Flight Procedure Tracking Form		Action: FLIGHT CHECK	Task Type: IAP	Date Open: 05/04/2017	Task #: 2015121713110301006	Request #: 20151217131103
Procedure: RNAV (GPS) RWY 7L AMDT 3			Airport ID: PANC	Airport: TED STEVENS ANCHORAGE INTL		Reimbursable #: NO
City: ANCHORAGE	ST: AK	GPS #:	Estimated Chart Date: 10/10/2019		FICO #:	
Fac ID: N/A		Fac. Type:			Specialist: TAYLOR GIBSON	
Procedure Review						
	Rec'd	Rel'd	Full Name	Comments		
Lead:	03/12/2019	07/02/2019	CHRIS MCCARTHY			
QA:	07/02/2019					
Liaison:						
Procedure Comments:			ENROUTE-NON	Remark Type: INFORMATION		
PENDING AIRPORT DATA USED. HARD DATE DUE TO AMENDMENTS COINCIDING WITH 15/33 RWY EXTENSION. CONTACT DAVE DANNER 405-954-5077

RNAV (GPS) RWY 7L

TED STEVENS ANCHORAGE INTL (ANC) (PANC)

Runway 15 threshold relocation and Runway 33 displaced threshold relocation require procedure amendments. Other minor changes also included in attached documentation.

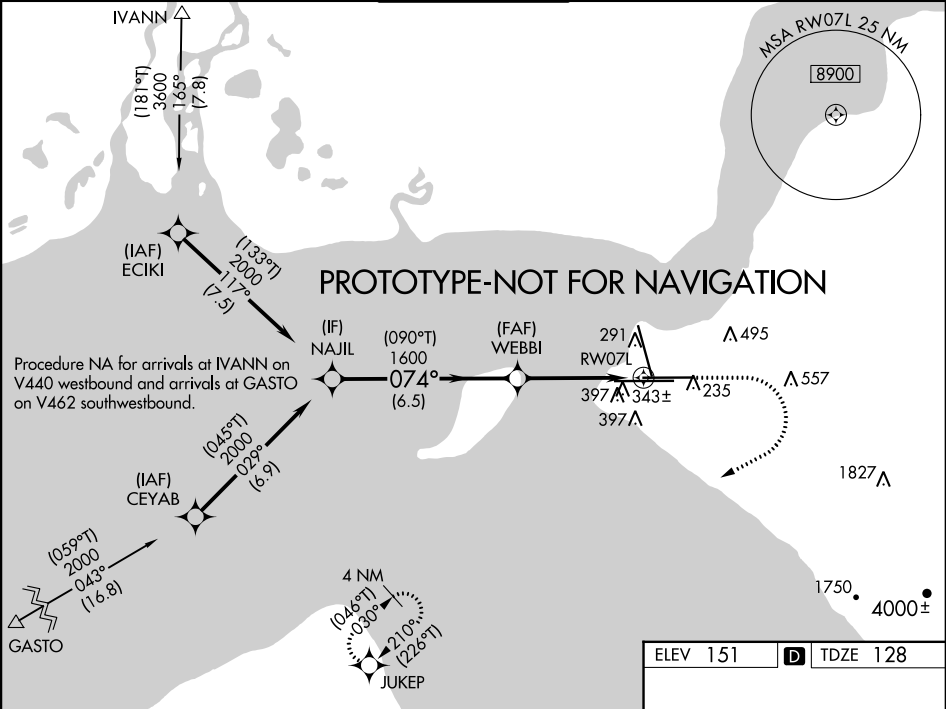
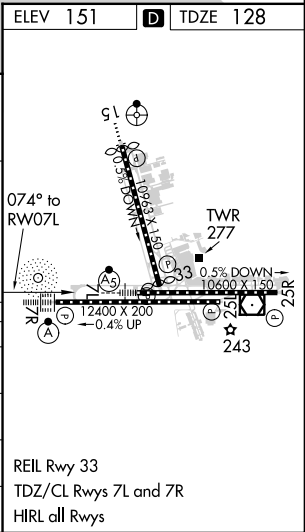
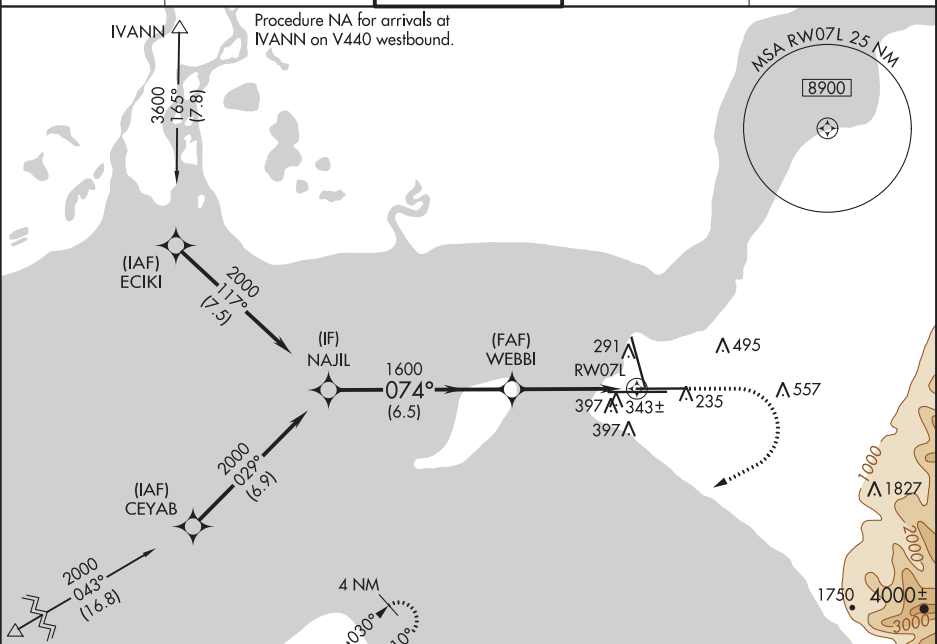
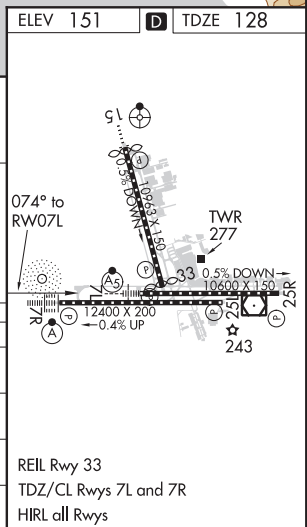
RNP APCH. ▼ For uncompensated Baro-VNAV systems, LNAV/VNAV NA below -18°C or above 54°C. For inop ALS, increase all LNAV/VNAV Cats and LNAV Cat C/D visibility to 1½ SM. ▲	MALS R AS	MISSED APPROACH: Climb to 800 then climbing right turn to 3000 direct JUKEP and hold.
--	--------------	---

NAJIL VGSi and RNAV glidepath not coincident (VGSi Angle 3.00/TCH 63). 2000 GP 3.00° TCH 54 074° 1600 6.5 NM 3.2 NM 1.3 NM 800 3000 JUKEP *LNAV only *1.3 NM to RW07L				
CATEGORY	A	B	C	D
LPV DA	328/18		200 (200-½)	
LNAV/VNAV DA	595/50		467 (500-1)	
LNAV MDA	600/24 472 (500-½)		600/50 472 (500-1)	
CIRCLING	700-1 549 (600-1)		800-1¾ 649 (700-1¾)	920-2½ 769 (800-2½)
